Inspection Photos

API: 055-06283

Operator: EDWARDS ENERGY CORPORATION

Inspection Date: 6/8/2023

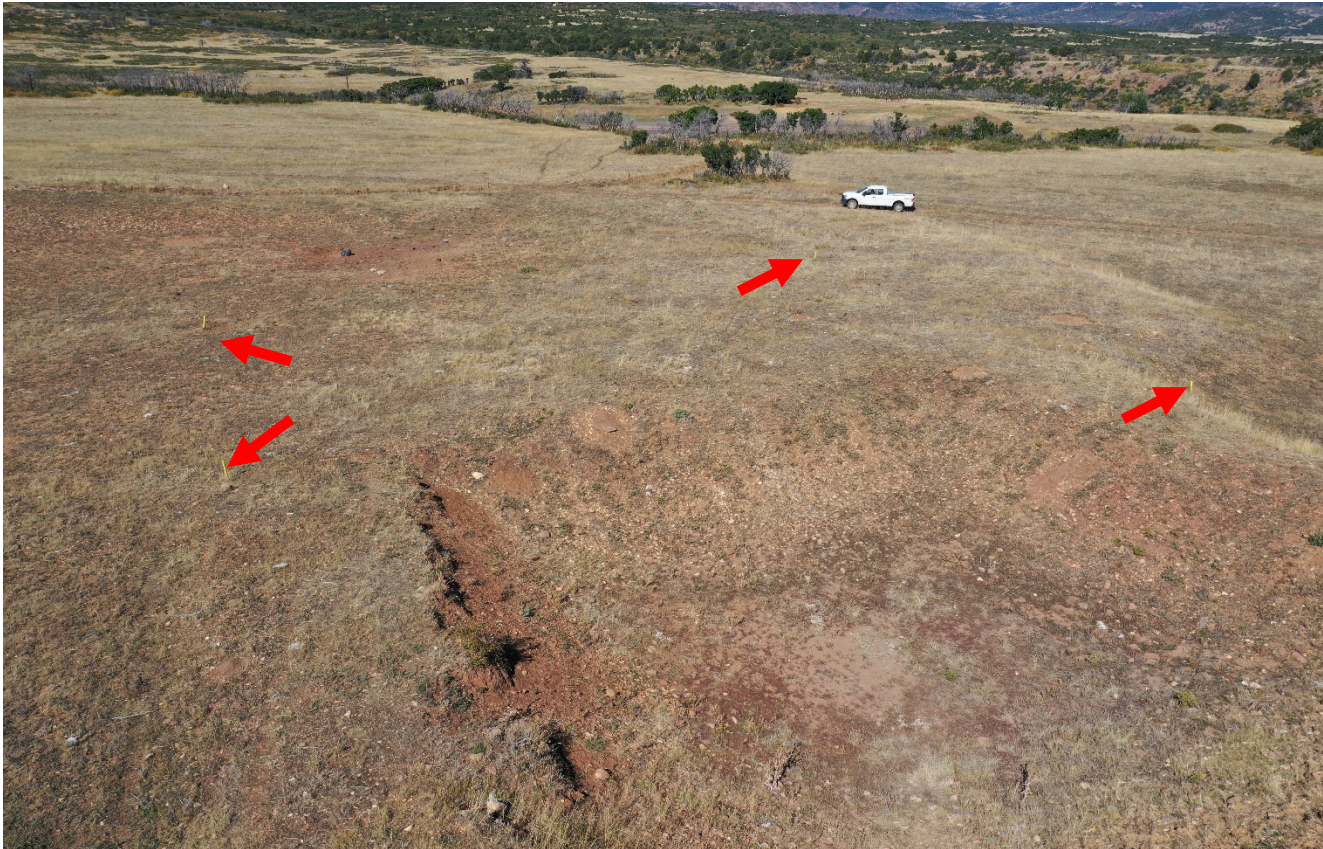
Photo 6. 2021 Drone aerial photo facing northwest. The red arrow points to the four guyline anchors that were never removed.
